ST. LUCIE UNIT 2

BORIC ACID CONCENTRATION REDUCTION

Marked-up Technical Specification Pages

Boric Acid Concentration Reduction
Safety Analysis

Figure 3.1-1
Minimum boric acid makeup tank volume and temperature as a function of stored boric acid concentration

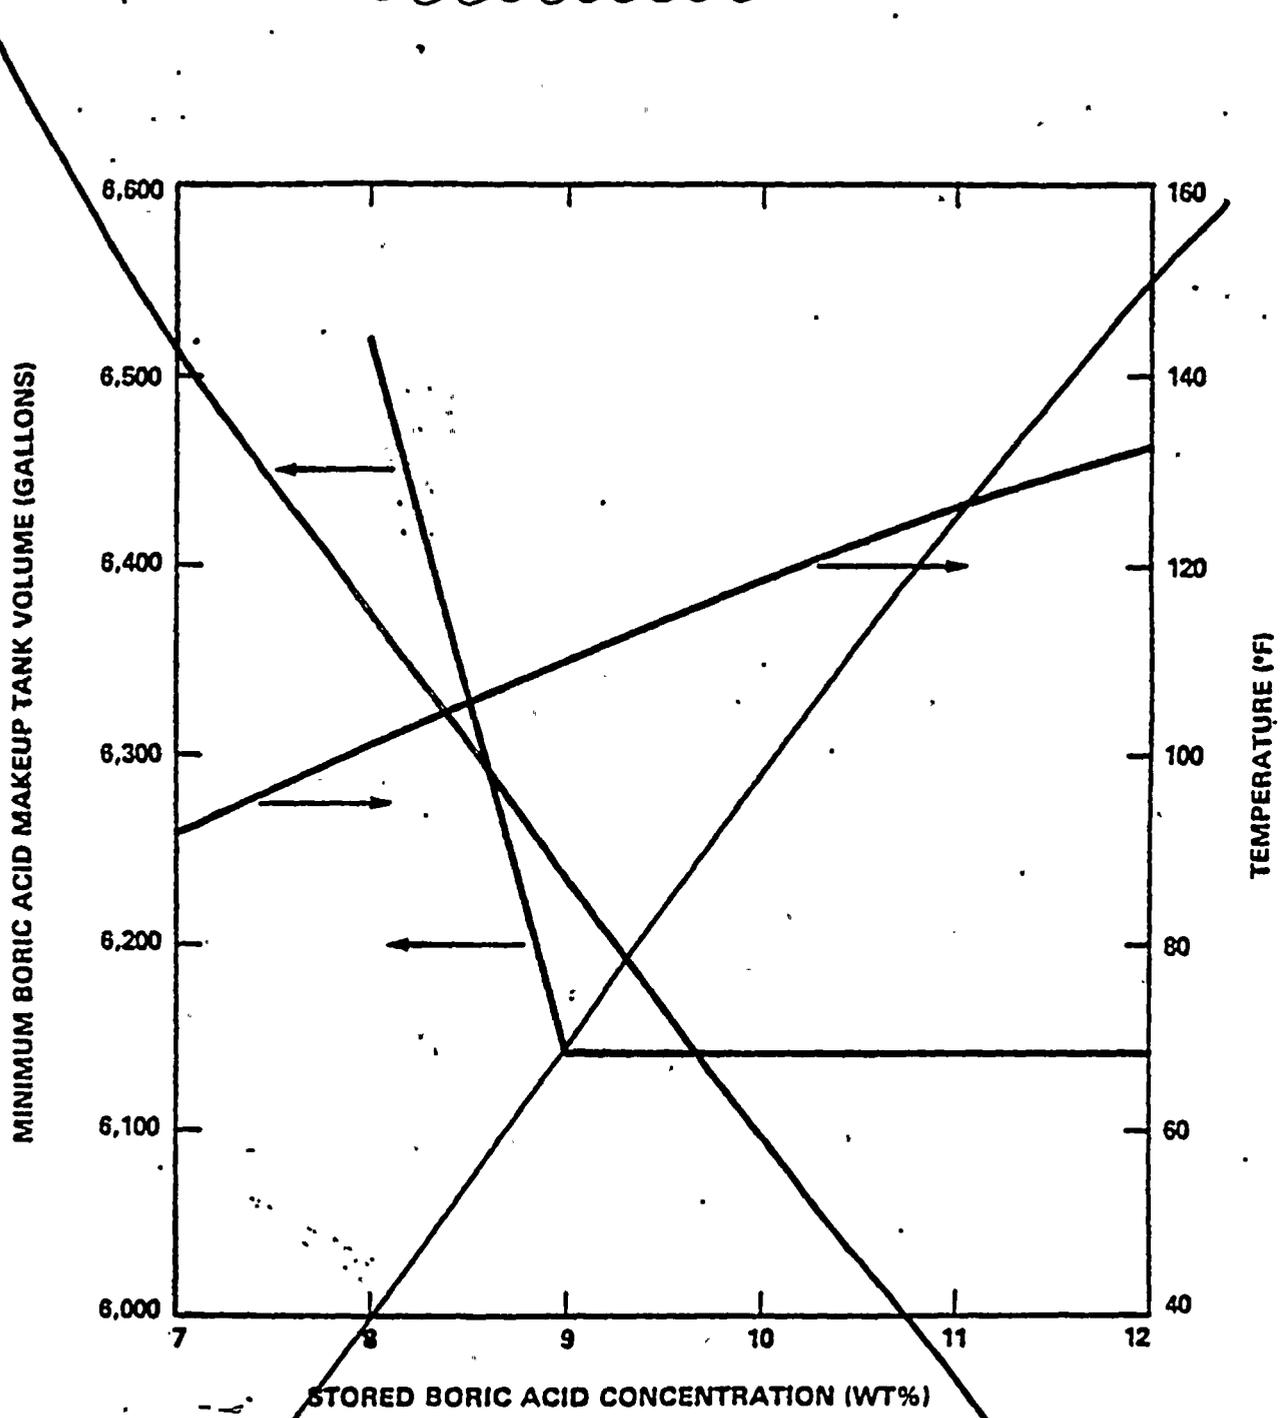
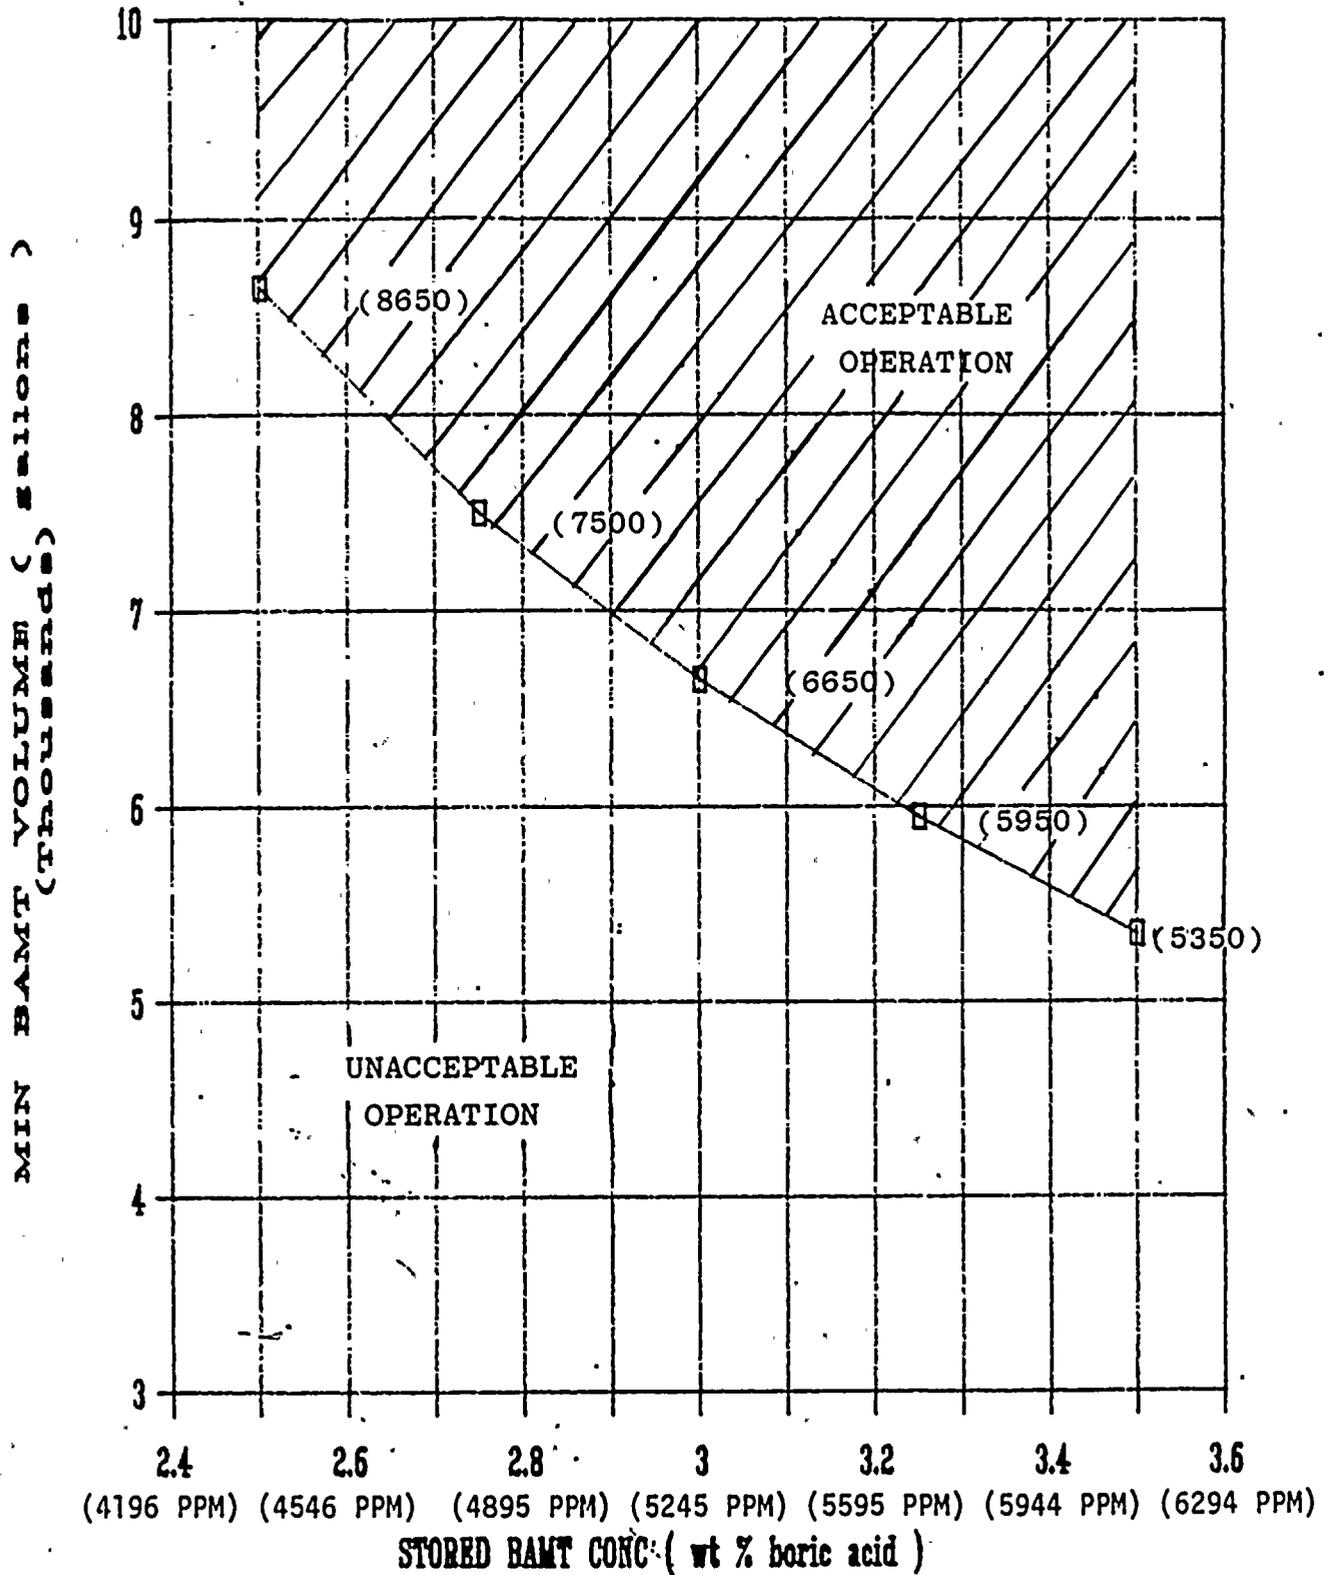
Delete and Replace
with New Figure 3.1-1

The figure specifies the minimum required Boric Acid Makeup water volume and temperature as a function of stored boric acid concentration. The revised figure specifies the minimum required water volume (contained in one or both Boric Acid Makeup tanks) above zero percent tank level as a function of boric acid concentration in the Boric Acid Makeup tank. This curve was generated in the topical report for a minimum refueling water tank boron concentration of 1720 ppm boron. This curve conservatively bounds Boric Acid Makeup tank minimum required water volumes for conditions when the refueling water tank boron concentration is greater than 1720 ppm. The range of boron concentration in the Boric Acid Makeup tank has been reduced from 8.0 to 12.0 weight percent boric acid to 2.5 to 3.5 weight percent. The upper range of the required borated water volume increases from 6,520 gallons to 8,650 gallons. The revised Figure 3.1-1 is consistent with the analytical results of the topical report (CEN-365(L)) for plant conditions at Operating Modes 1 through 4 to maintain the required safe shutdown margin. The temperature versus BMT concentration curve has been removed since it is no longer required.

The existing Figure 3.1-1 specifies the maximum volume of the BMT to be 6,520 gallons at a minimum concentration of 8.0 weight percent. The proposed changes are to provide a new range of boric acid concentration of 2.5 to 3.5 weight percent for one or both of the Boric Acid Makeup tanks. The revised volumes of Figure 3.1-1 lower the minimum water volume to 5,350 gallons. Deletion of the requirement to heat trace the Boric Acid Makeup system is consistent with the ability to maintain 2.5 to 3.5 weight percent boric acid in solution at temperatures above 50°F. The revised surveillance requirements deletes verifying Boric Acid Makeup tank temperature unless

For Modes 1 through 4 the proposed changes revise the boric acid concentration and volume requirements for the Boric Acid Makeup tank in accordance with the proposed Figure 3.1-1 and the corresponding minimum required borated water volumes of between 12,000 and 16,000 gallons with boron concentration of 1720 ppm from the RWT or 40,000 gallons with boron concentration of 1720 ppm from the RWT alone.
